F/SER31:MET  
SER-2015-17048

MEMORANDUM FOR: F/HC3 – Jamie Schubert

FROM: F/SE – Roy E. Crabtree, Ph.D. *RC*

SUBJECT: Deepwater Horizon-Early Restoration Plan  
Phase III, Endangered Species Act Section 7 Consultations  
for Hancock County Marsh Living Shoreline Project: Re-Initiation  
of ESA Consultation

Figure 1. Modified Hancock County Marsh Living Shoreline Project footprint compared to previously evaluated component areas

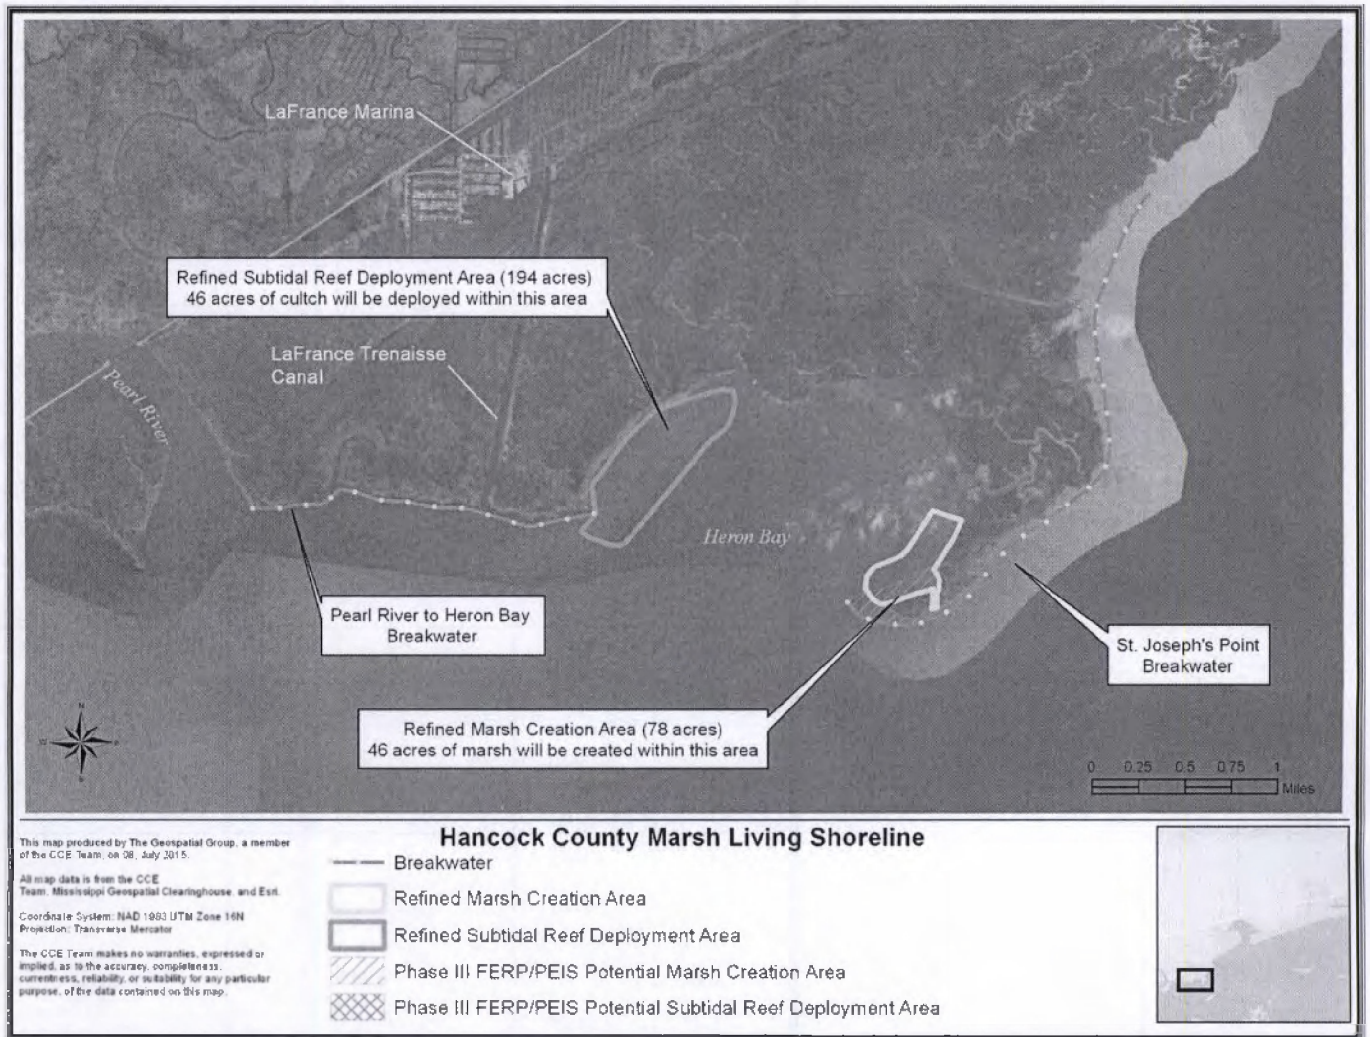
- The breakwater height has been increased from mean low water to mean higher high water to facilitate increased shoreline protection.
- Commensurate with breakwater height increase, the breakwater base width has been increased from 30 feet (ft) to 60 ft, resulting in a net increase in the breakwater footprint of 23 ac.

- Approximately 123.1 ac of the flotation channels/sidecast sediments have been eliminated from the project.
- The Potential Subtidal Reef Deployment Area shown in the Final Phase III ERP/PEIS has been refined based on field studies. The Refined Subtidal Reef Deployment Area is a 200-ac area in the western portion of Heron Bay. Approximately 46 ac of cultch will be deployed in one to several locations within this area (Figure 1).

- The Potential Marsh Creation Area shown in the Final Phase III ERP/PEIS has been refined based on field studies. The Refined Marsh Creation Area is a 76-ac area in the southeastern portion of Heron Bay. Approximately 46 ac of marsh will be created in one to several locations within this area (Figure 1).

Figure 1 depicts the resulting modifications to the project's footprint, and Table 1 quantifies the specific increases and decreases in the overall footprint. These changes do not impact the project's overall objectives, which are to (1) construct reef structures to protect shoreline from erosion and support secondary productivity, (2) restore marsh habitat, and (3) restore subtidal reefs to support secondary productivity.

Based on the preceding analysis, we concur with your project-effect determination that the project for which you requested ESA consultation is not likely to adversely affect Kemp's ridley, loggerhead, or green sea turtles, Gulf sturgeon, or Gulf sturgeon critical habitat.
